Fmax for Coupling & Screening Attenuation

Eric DiBiaso

What's in Draft 2.1?

Figure 149-44—Coupling attenuation calculated using Equation (149-24)

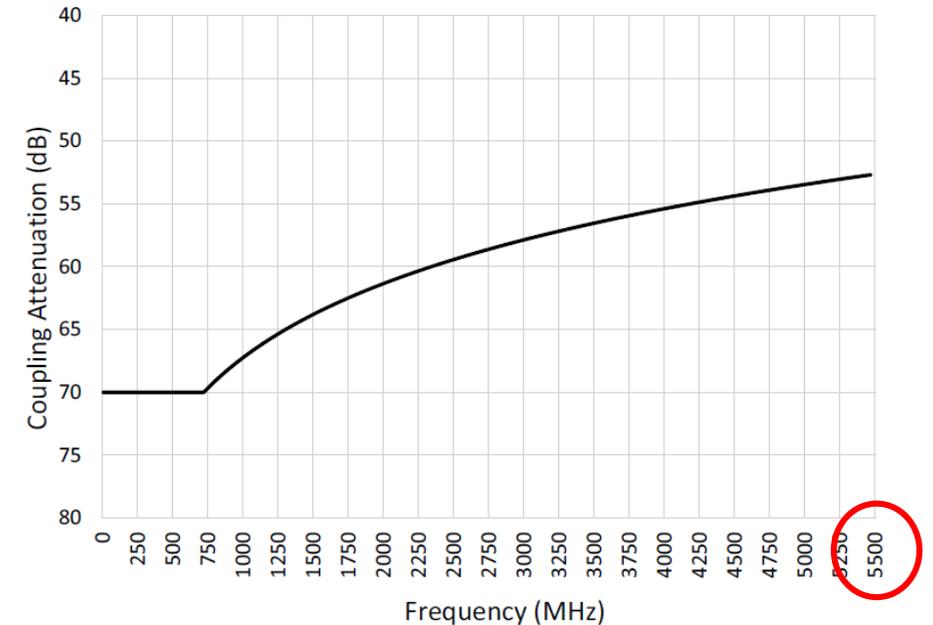
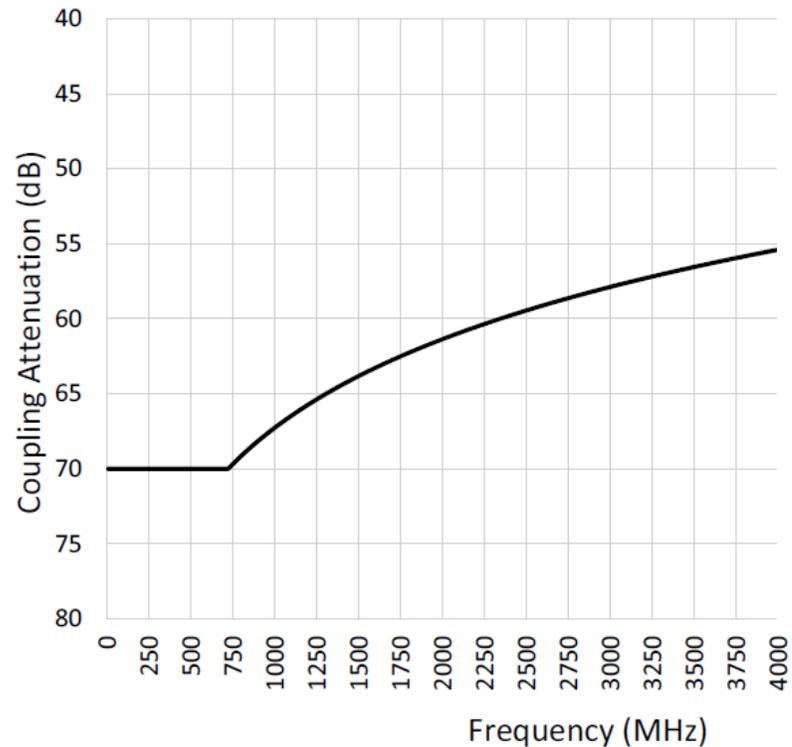
Option 1: Equation (149-24) is correct

Only need to modify Figure 149-44 by removing all frequencies above 4000MHz.

Or is Figure 149-44 correct?

Figure 149-31: Coupling attenuation calculated using equation (149-26)

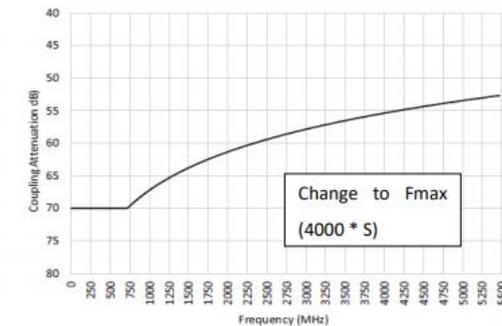
Or is Figure 149-44 correct?

Replace subclause 149.7.1.5 Shielding attenuation with subclause 149.7.1.5 Screening attenuation, title and content, as shown on page 1 of mueller_3ch_04_0319.pdf and grant editorial license to implement the proposal.

Figure 149-40—Transmitter Power Spectral Density, upper and lower masks

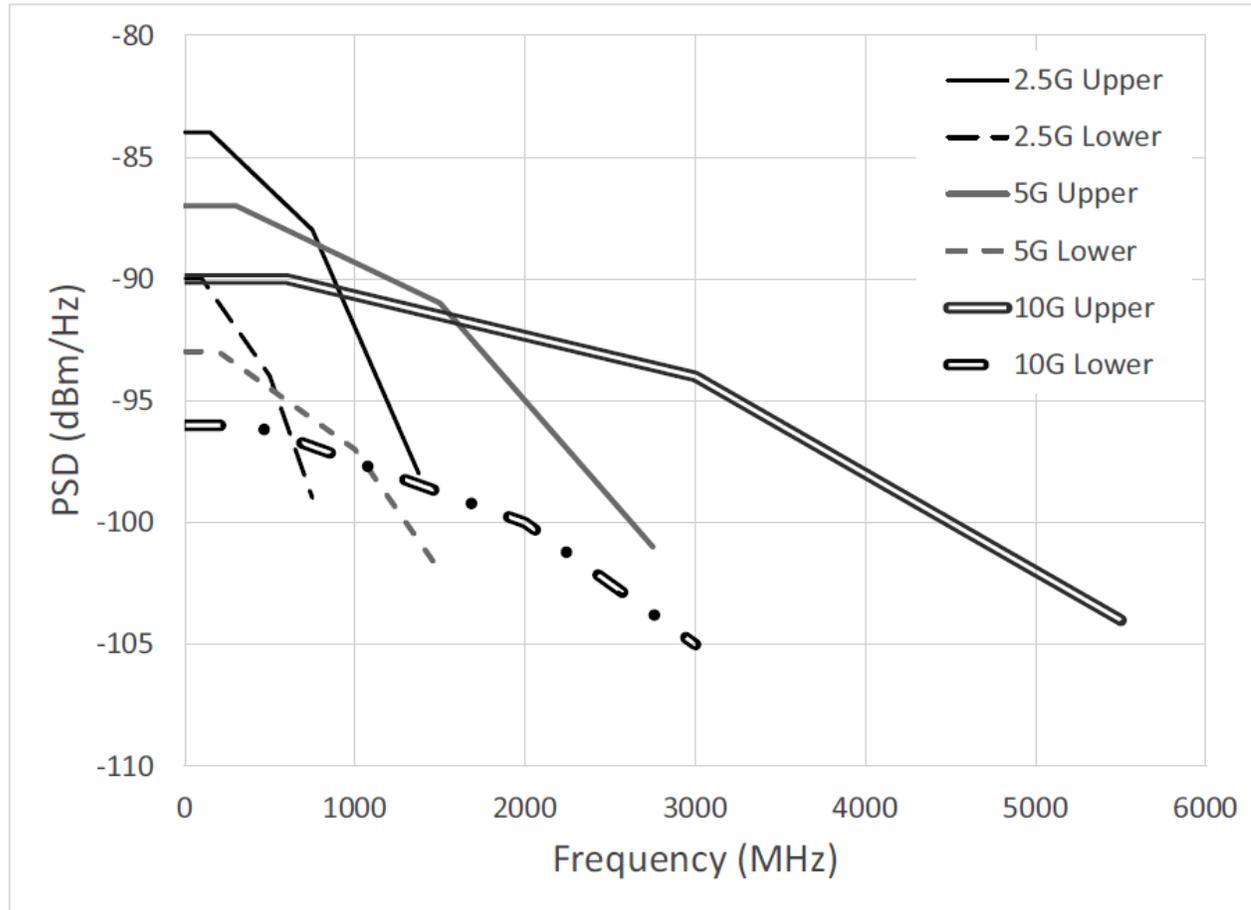
Should Fmax be aligned to Transmitter PSD?

Figure 149-44—Coupling attenuation calculated using Equation (149-24)

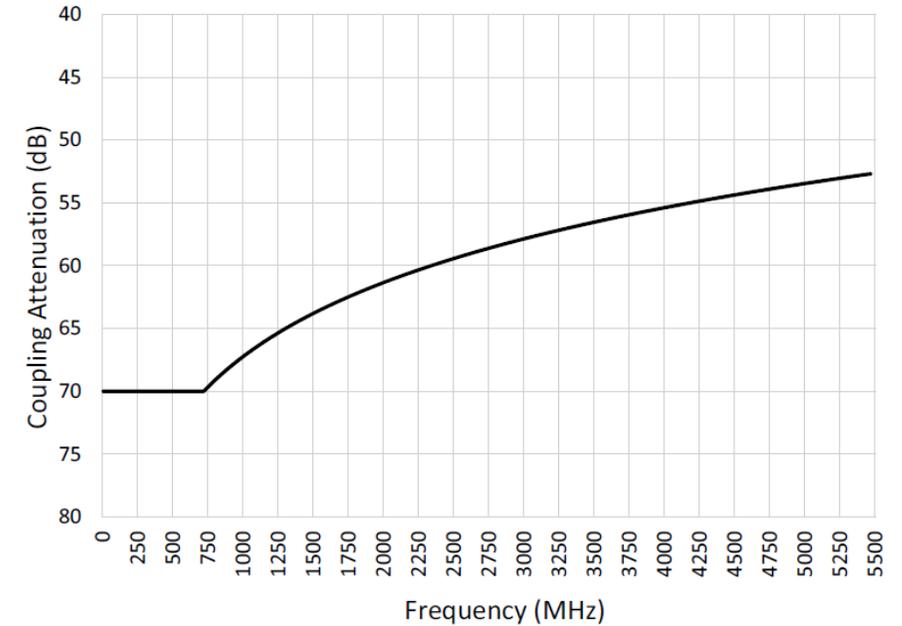
Option 2: Change Fmax to 5500 x S

- Two solutions were given to resolve the F_{max} discrepancy between equation 149-24 and Figure 149-44.
- My recommendation is that Coupling and Screening attenuation should be aligned with upper frequency limit of Transmitter PSD

$$\text{Coupling Attenuation}(f) \geq \begin{cases} 70 & 30 \leq f \leq 750 \text{ MHz} \\ 50 - 20 \log_{10} \left(\frac{f}{7500} \right) & 750 \leq f \leq F_{\text{max}} \text{ MHz} \end{cases} \text{ (dB)} \quad (149-24)$$

f is the frequency in MHz; $30 \leq f \leq F_{\text{max}}$
